# Review of the Monolith Materials Inc. Groundwater Flow Model

**Lower Platte South Natural Resource District**

February 2021

**FIGURE 1  
ACTIVE GRID  
AND WELL LOCATION**

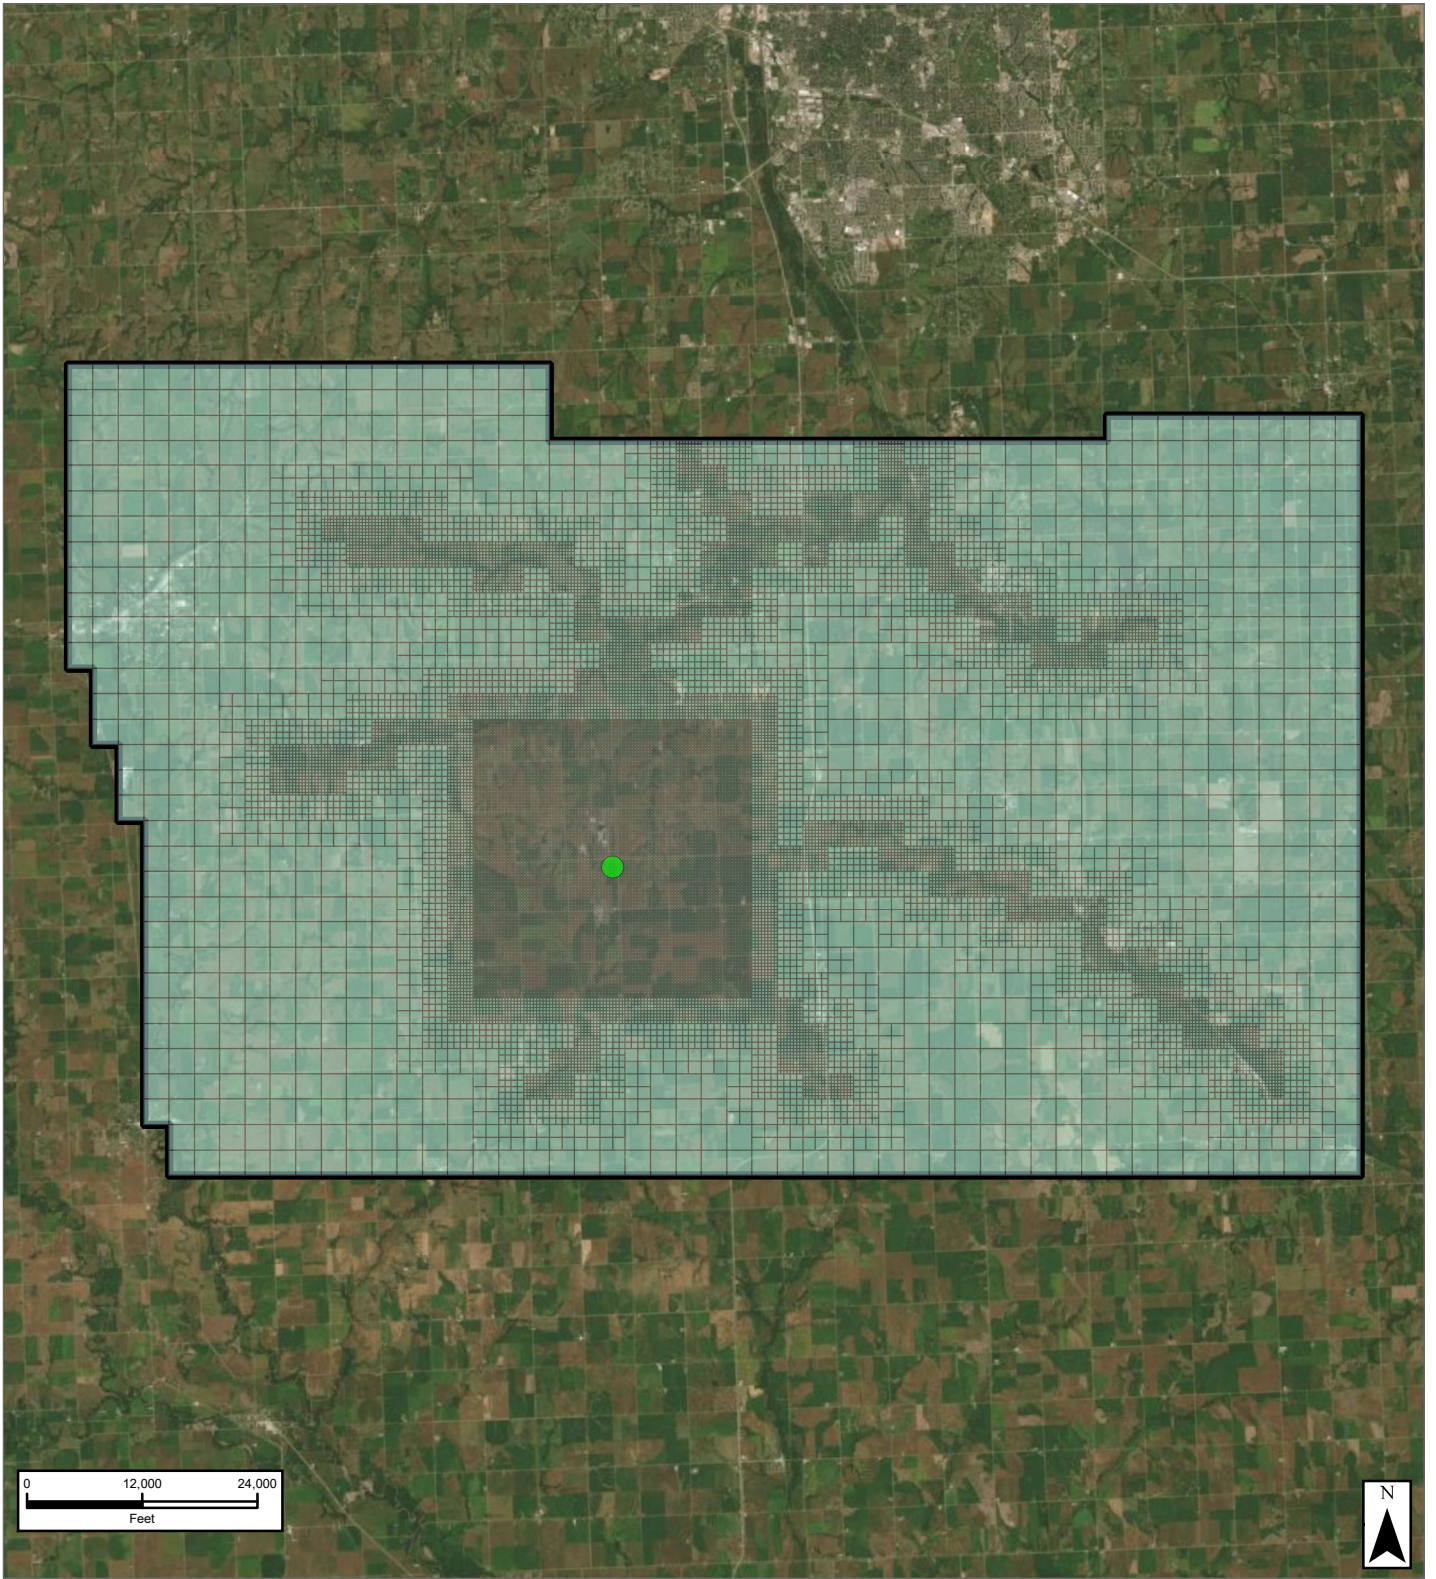
The extent and spatial discretization of the Model is shown on **Figure 1**. The projected geographic coordinate system utilized is State Plane Nebraska FIPS 2600. The units are in feet (ft). The southeast corner of the model is located at 245520 ft Northing and 2477635 ft Easting. The spatial discretization is variable and ranges from 165 ft square to 2640 ft square. The smallest discretization surrounds the streams and the Monolith Well on the Site.

The model encompasses a total active model area of approximately 373 square miles and adequately bounds the influence of the Monolith Well location. The temporal discretization consists of 600 transient stress periods. Each stress period has one-time step and is 30.43 days long.

It is our opinion that the set-up of the extent, spatial, and temporal discretization allow for an adequate assessment of the Model objectives.

**HYDROGEOLOGIC CROSS SECTIONS A-A' AND B-B'**

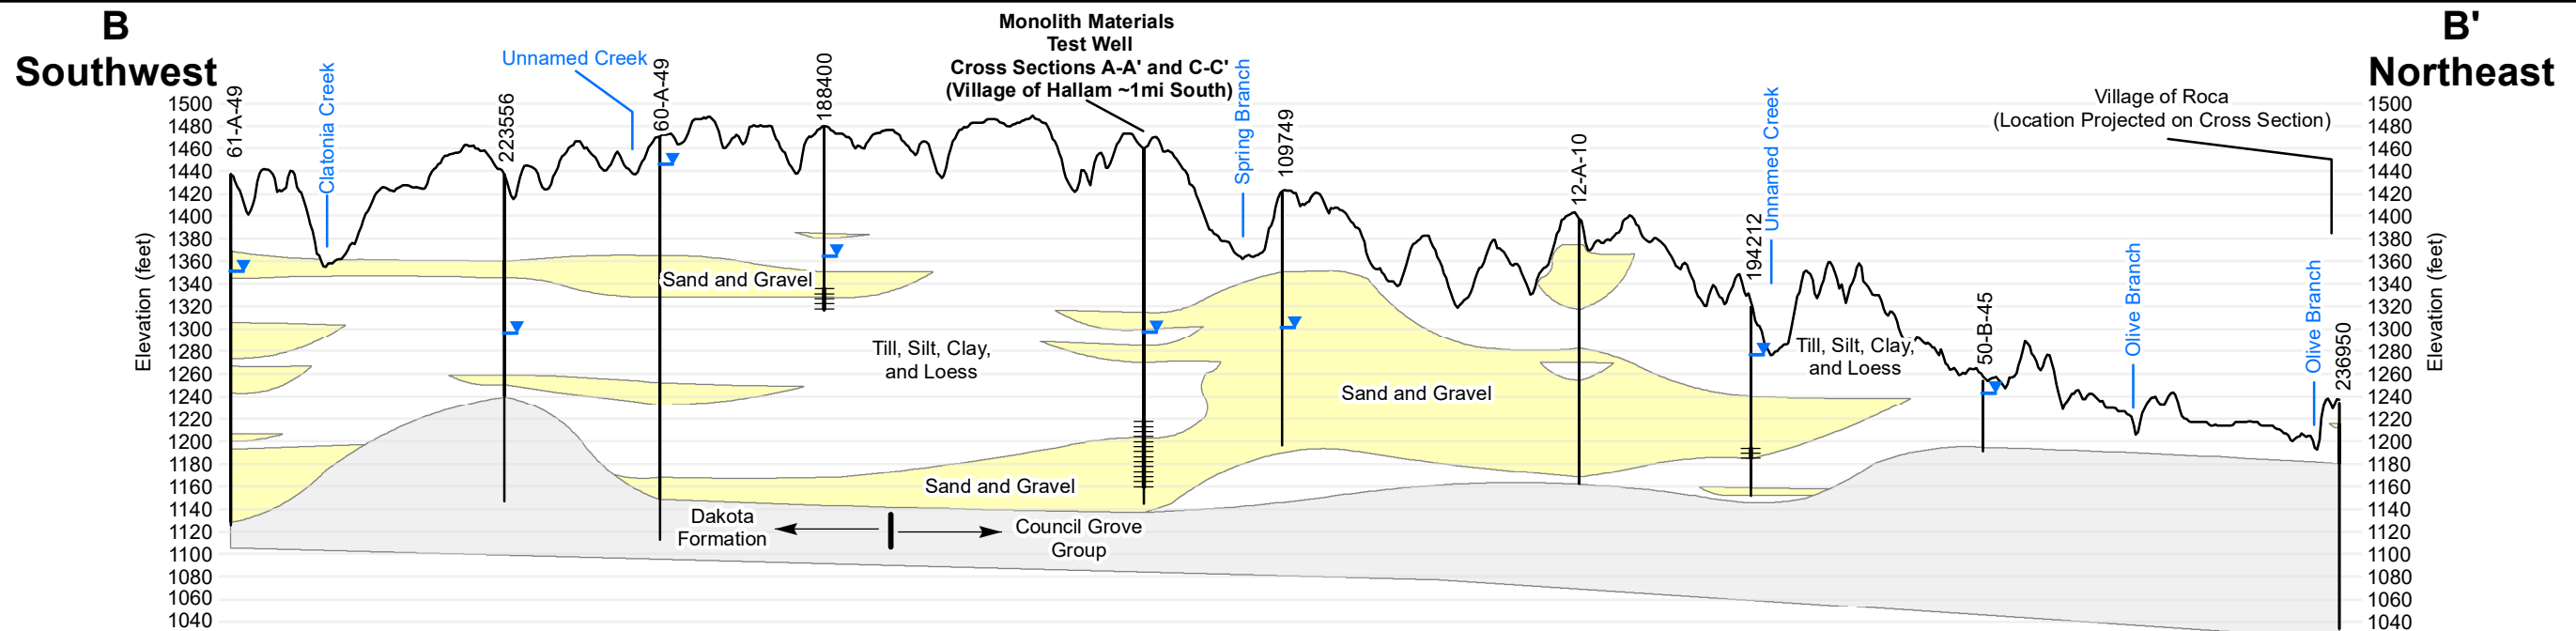
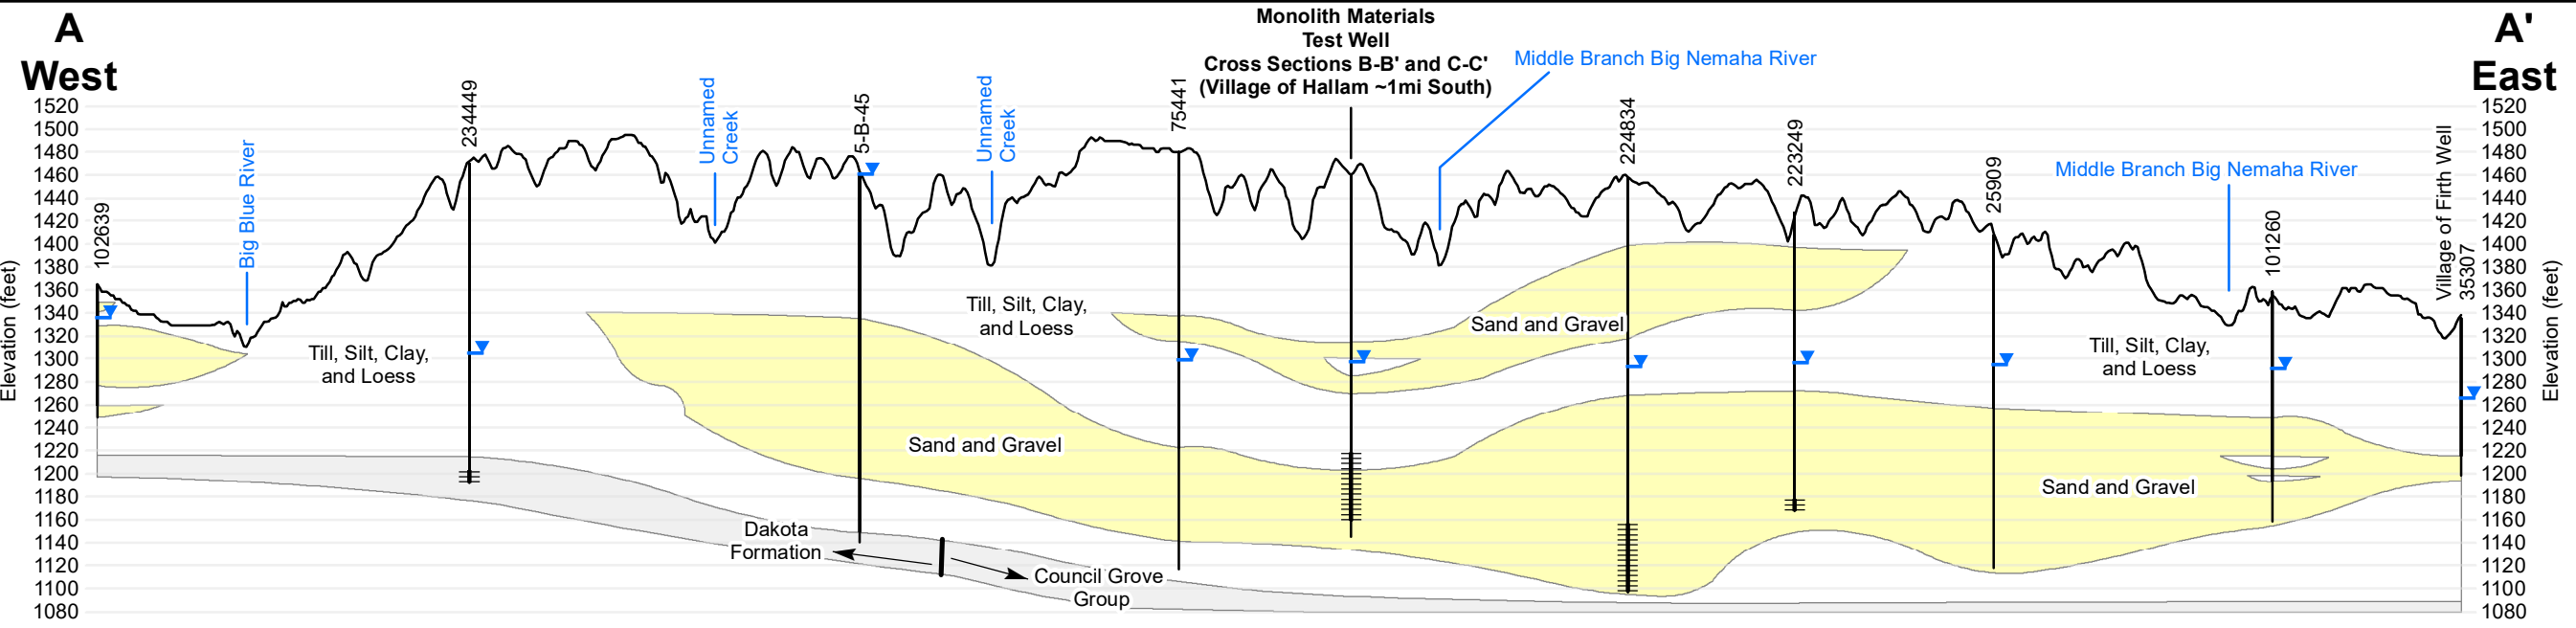
To assist in our evaluation of the conceptual hydrogeology of the Model domain, LRE constructed three hydrogeologic cross sections through the locations shown on **Figure 2**. The cross sections are referenced at A-A', B-B', and C-C' and are shown on **Figures 3 and 4**. Based on our review of geologic information, including borehole logs, the cross sections, and peer reviewed publications, it is our opinion that the structure of the CPA aquifer represented in the Model represents the known geology adequately.

**Figure 5**  
**Cumulative Water Budget Difference For**  
**Pumping and Non-Pumping Scenarios**  
**(acre-ft/year)**

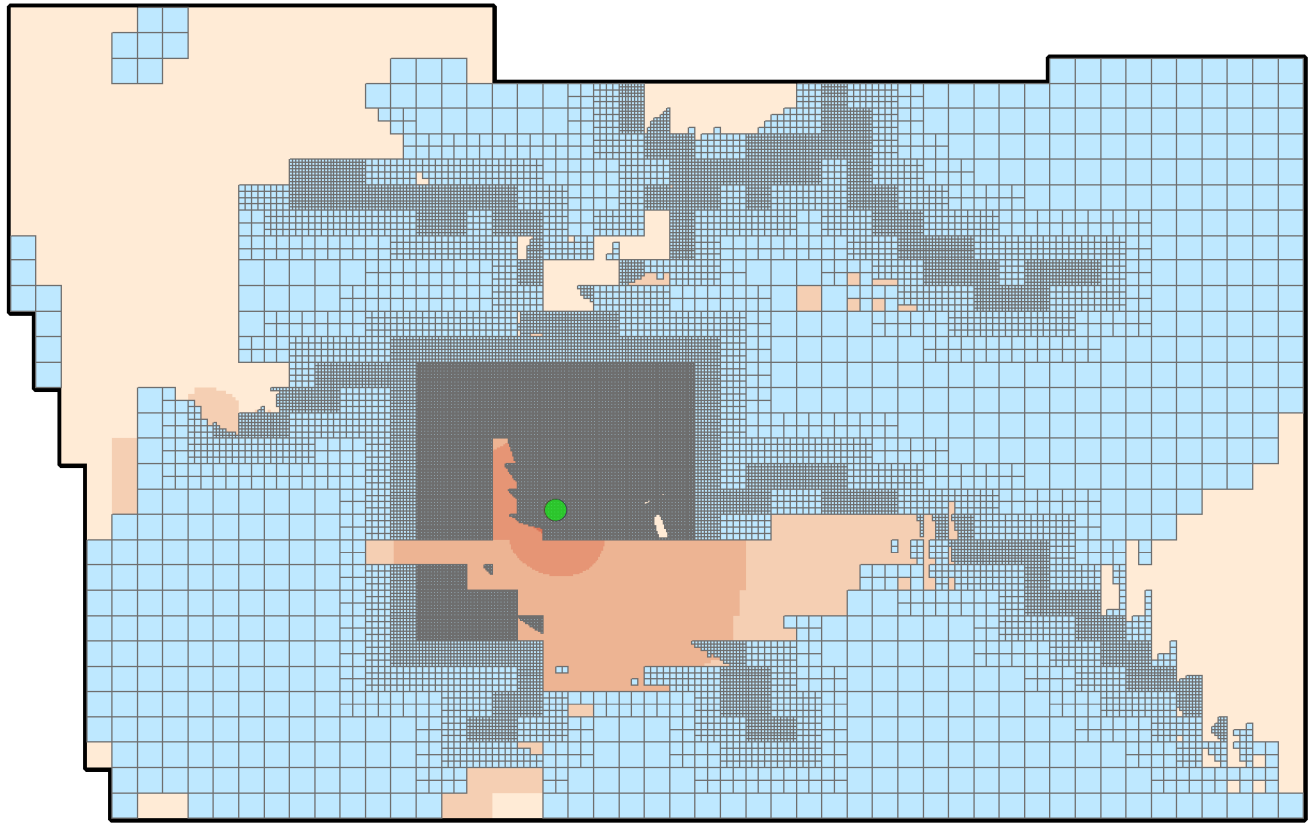
Another main object of the Model is to simulate the effect of pumping on surface streams. To review this, we compared the modeled water budget for the Monolith pumping and no-Monolith-pumping scenarios. The model budget difference highlights the source of water to the Monolith Well. The differences from pumping can be seen in **Figure 5** and **Table 1**. The surface water contributions (River and Streams) account for 52% of the water pumped from the Monolith Well over 50 years. Water coming from aquifer storage accounts for 31%. The remaining significant portion (16%) comes from the General Head Boundaries from the North, South, and East. Our results are identical to the results presented by the Model. The predicted reduction in stream flow of 452 acre-feet per year is equivalent to a reduction of approximately 0.6 cubic feet per second (cfs). The impact to the GHB Boundaries of 157 acre-feet per year is equal to an additional 0.2 cfs which is likely to manifest as a reduction in outflow to streams outside of the model domain. Together, these comprise a total predicted stream flow reduction of approximately 0.8 cfs.

Future Scenario Declines With Monolith Pumping  
 Monolith OC2  
 Groundwater Modeling Report  
 Lancaster County, NE

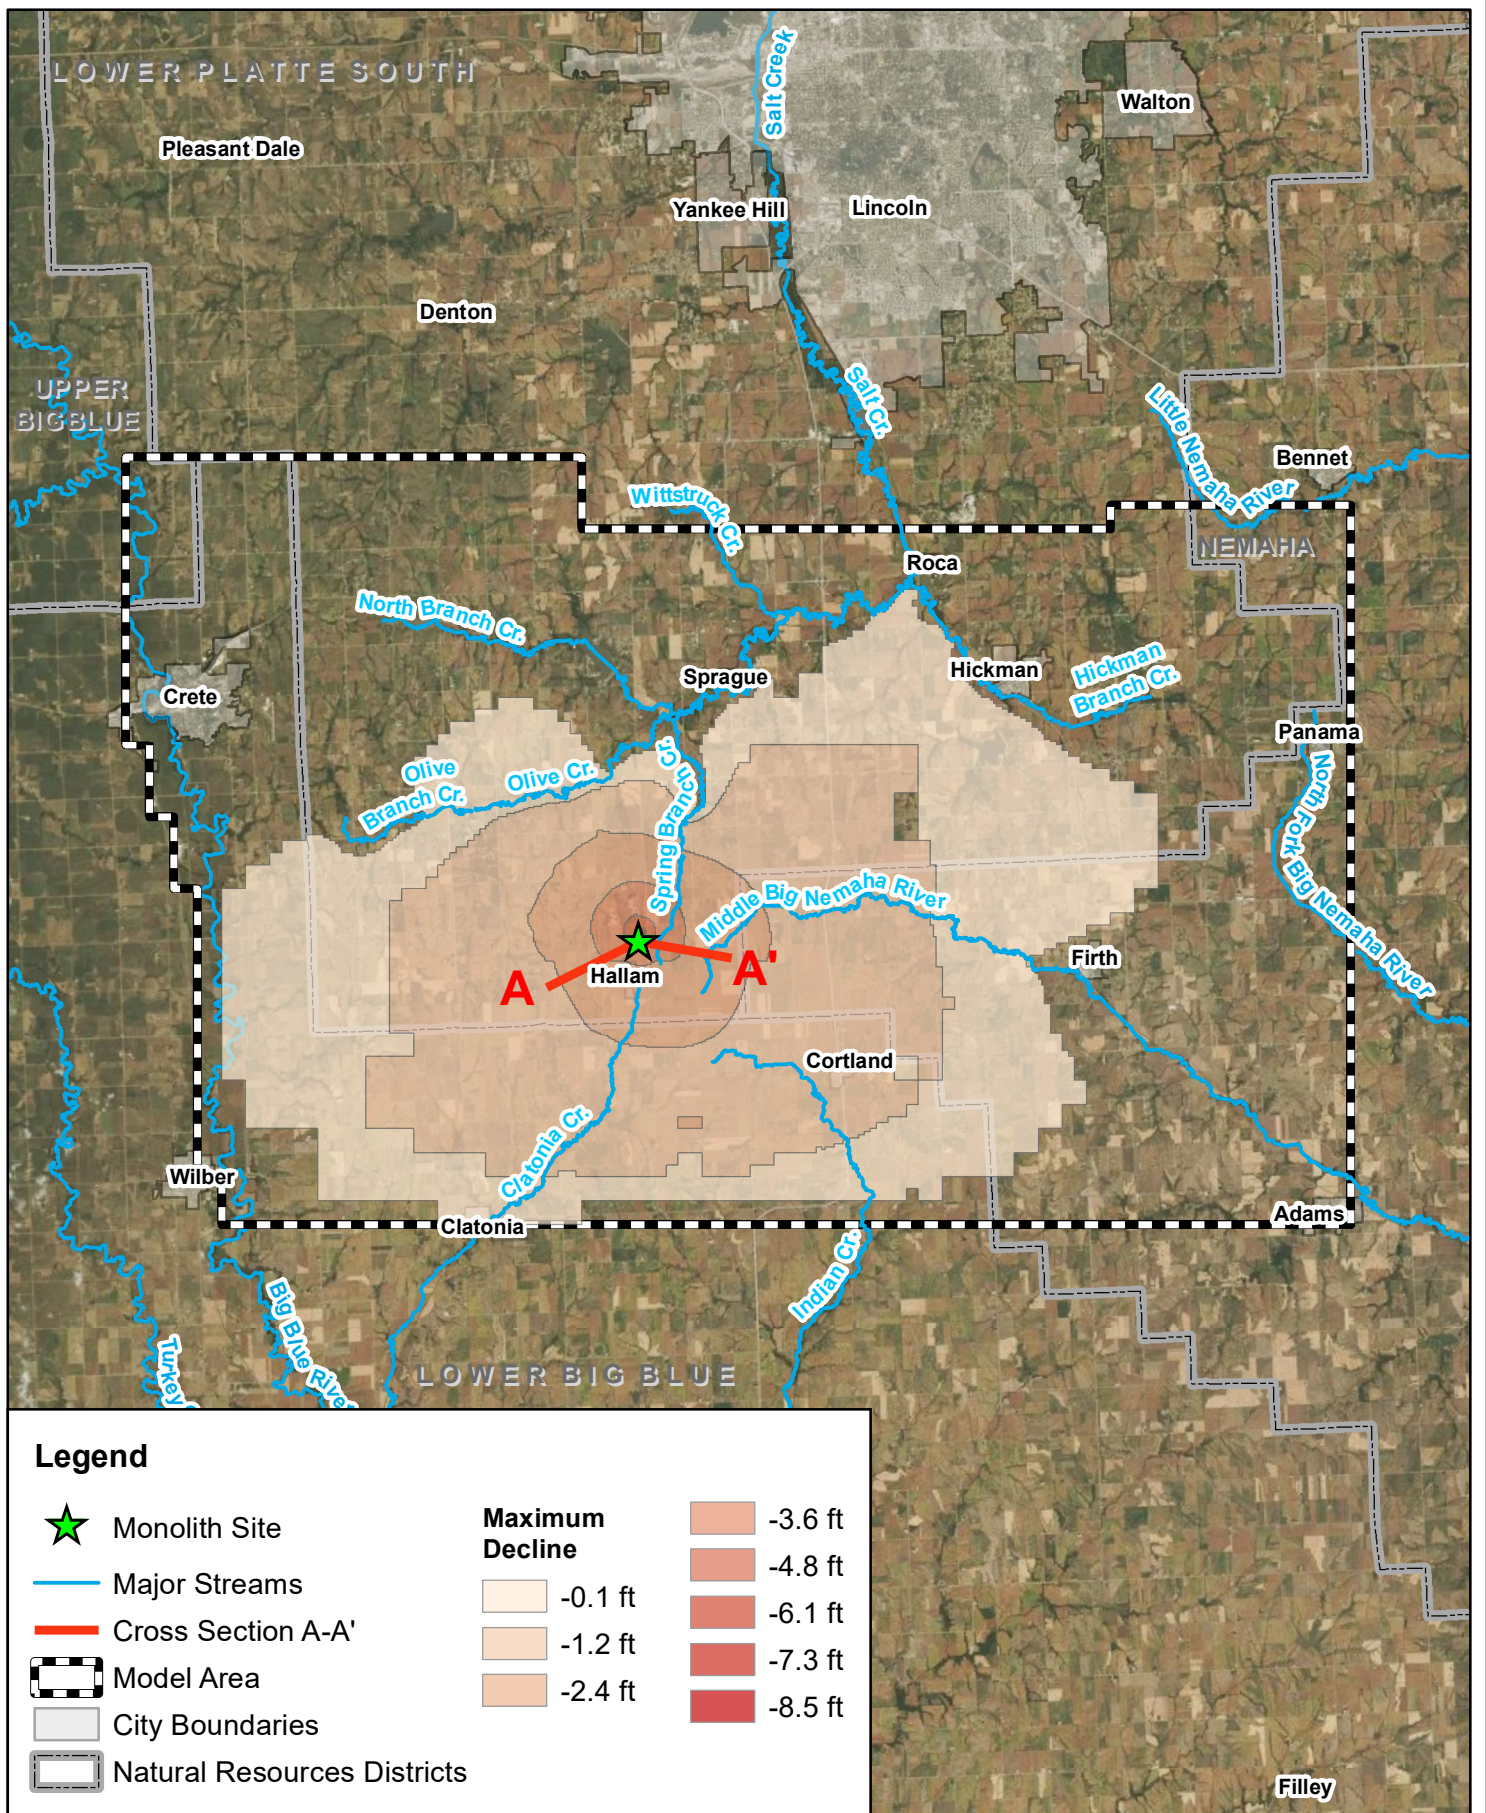
A water table drawdown map was created for each layer in the Model, comparing the final time step at the end of 50 years (**Figures 6-9**). The drawdown in all layers (**Figure 10**) was used to create a full drawdown map. Comparing these results to figure 3.14 in the Olsson (2020), (**Appendix A**) we find that they are very similar, but not exactly the same. The first difference is that Appendix A shows the contour interval with a maximum decline of -0.1 feet, but it is not shown. The second is that the maximum drawdown in all layers on the final time step of the Model is 6.9 feet near the Monolith Well. **Appendix A** shows contours up to -8.5 feet and that amount of drawdown is referenced in the Discussion section of the Olsson (2020). Lastly some of the contour intervals are slightly different from each other. These differences in **Figure 10** and **Appendix A** do not change our opinion on the overall Model. We suspect that the minor differences we encountered are due to differences in initial heads, contouring methods, or the exact time used for the drawdown analysis. These minor differences do not affect the overall conclusions of our analysis, however, we recommend providing a model addendum to document exactly how Olsson's drawdown maps were developed.

- b. Horizontal / vertical hydraulic conductivity ratio (kh/kv) in all layers.
2. Provide an addendum with directions for exact replication of future drawdown simulations presented by Model results. This will be useful for documenting and comparing the current model results.
